Service Info

Renault** - 231 0103 10 - 310/310 TGU6

New design / Neues Design / Nouvelle conception / Nuevo diseño / Nuovo disegno

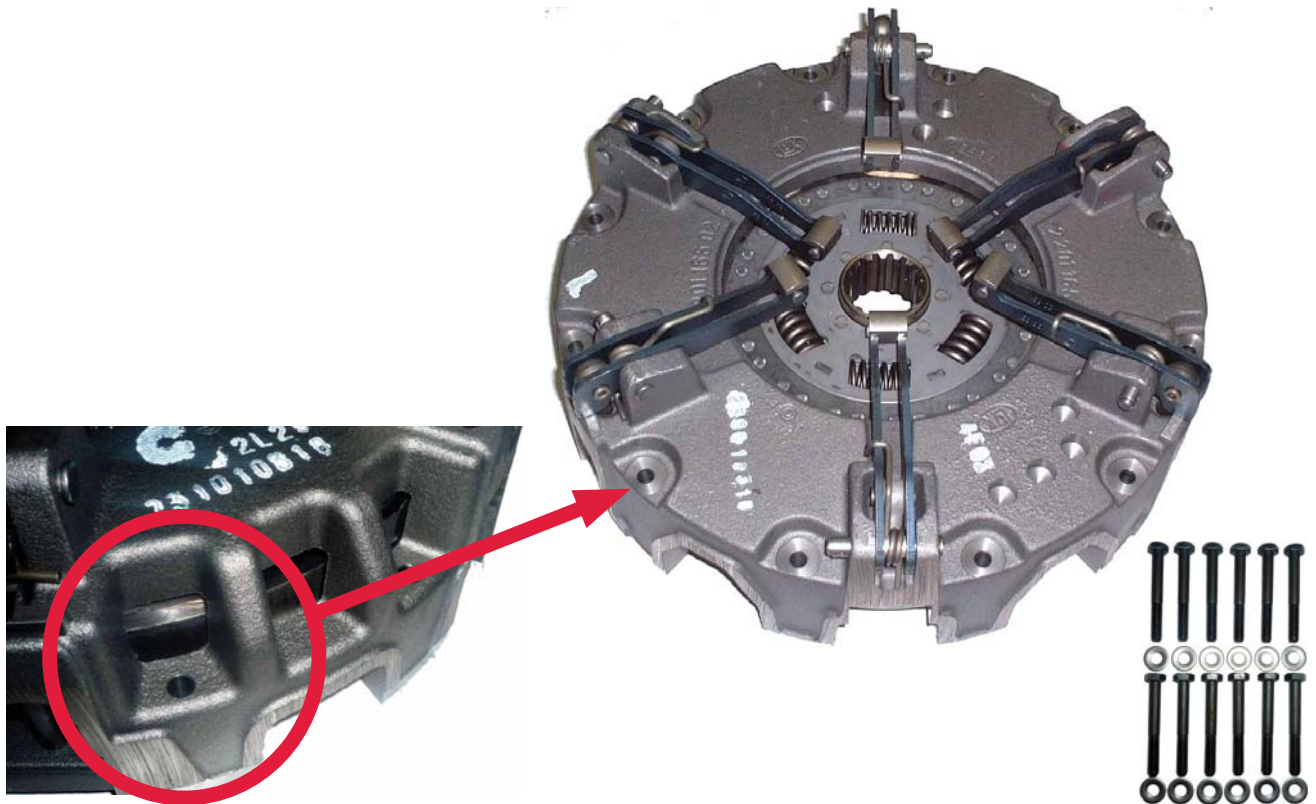
This new design utilises the latest clutch technology, using a vented housing for improved cooling and heat dispersal.

**Fully interchangeable with existing clutches with no modifications required to vehicle or flywheel.
New fixation bolt set 12 x M8 x 1.25 x 65mm is supplied with new designs to accommodate the lower housing.**
